September 29, 1998

Subject: Proposed Set of Amendments to UVAR Technical Specifications (TS); University of Virginia Reactor, Docket No 50-62, License R-66.

# LISTING OF AND JUSTIFICATIONS FOR PROPOSED CHANGES TO UVAR TECHNICAL SPECIFICATIONS

UVA REACTOR FACILITY  
ORGANIZATIONAL CHART  
FIGURE 6.1

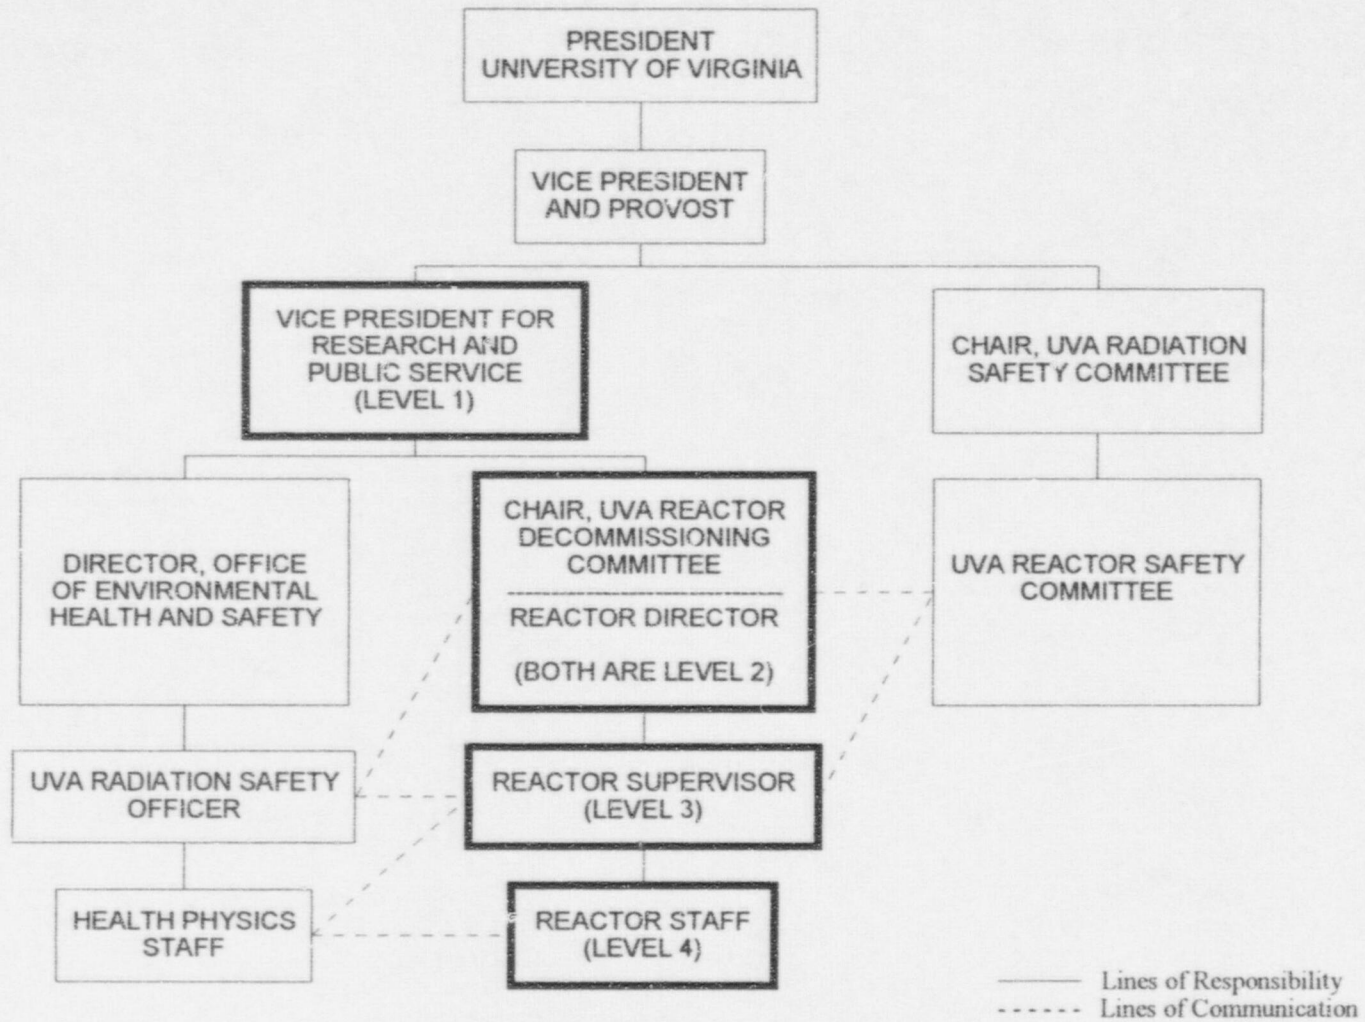
The Reactor Facility shall be an integral part of the University of Virginia. The organizational structure of U.Va. relating to the Reactor Facility is shown in Figure 6.1. *The Vice President for Research and Public Service (Level 1) shall have overall responsibility for management of the Facility.*

*See enclosed revised Figure 6.1 Organizational Structure of U.Va. Relating to Reactor Facility*
